Item Name: Aft Crosstube Support Change

# DART SERVICE INSTRUCTION

TO AMEND INSTALLATION INSTRUCTIONS IIN-D205-594 Rev. C (AND EARLIER) AND INSTRUCTIONS FOR CONTINUED AIRWORTHINESS ICA-D205-594 Rev. C (AND EARLIER) REF. CANADIAN STC: SH03-6 REF. FAA STC: SR01742NY

B	REPLACE MS21920-24 WITH MS21920-25 ON -101/-105; ADDED EXTRA NOTE TO INSTALLATION PROCEDURE (STEP 7)	MB	07.12.04
A	NEW ISSUE	MB	07.11.16
REV.	DESCRIPTION	BY	DATE
DESIGN		DART AEROSPACE LTD HAWKESBURY, ONTARIO, CANADA	
DRAWN		DRAWING NO. REV. B DSI 9396 SHEET 1 OF 2	
CHECKED		TITLE SCALE CROSSTUBE SUPPORT CHANGE NTS	
MFG. APPR.		COPYRIGHT © 2007 BY DART AEROSPACE LTD THIS DOCUMENT IS PRIVATE AND CONFIDENTIAL AND IS SUPPLIED ON THE EXPRESS CONDITION THAT IT IS NOT TO BE USED FOR ANY PURPOSE OR COPIED OR COMMUNICATED TO ANY OTHER PERSON WITHOUT WRITTEN PERMISSION FROM DART AEROSPACE LTD.	
APPROVED			
DE APPR.			
DATE	07.12.04

**FIGURE 1: INSTALLATION OF SUPPORT ON CROSSTUBE**

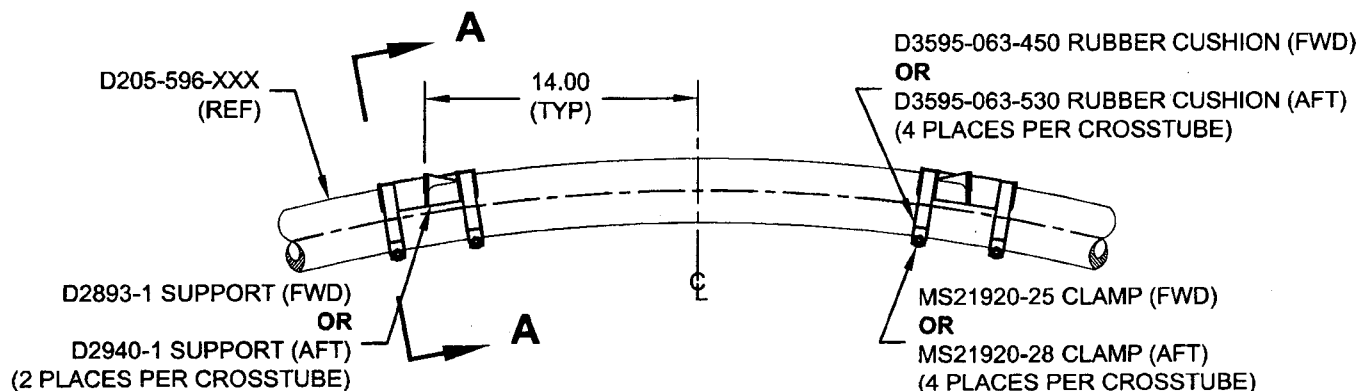
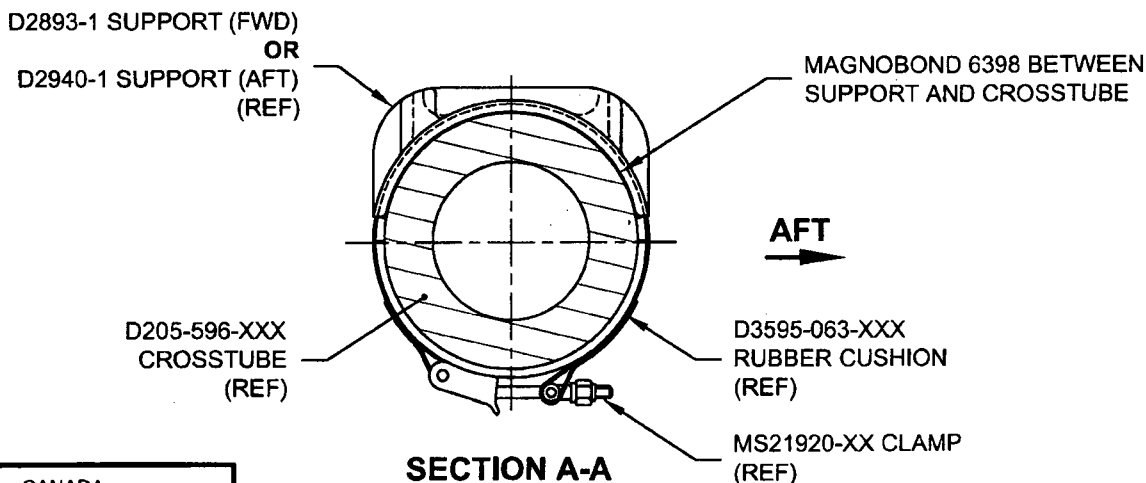
To prevent the supports from shifting on D205-596-101/-103/-105/-107 Crosstubes at CHG 001, the D2893-1 or D2940-1 Supports should be removed and re-installed as follows:

- 7) Apply a 0.03" to 0.06" thick layer of Magnobond 6398 underneath D2893-1 or D2940-1 Supports and re-install the Supports on the crosstube as shown in Figure 1. Install a D3595-063-450/-530 Rubber Cushion on each MS21920-25/-28 Clamp. Position and secure the D2893-1 or D2940-1 Supports on the crosstube using MS21920-25/-28 Clamps. Torque clamps to 80-100 in-lb. Let the D205-596-101/-103/-105/-107 Crosstube Assembly cure before re-installing the crosstube on the aircraft.

**Note:** It is acceptable to substitute the MS21920-25/-28 with longer or shorter clamps to accommodate varying diameters. Ensure there is a minimum of 1.5 threads in safety on the nut.
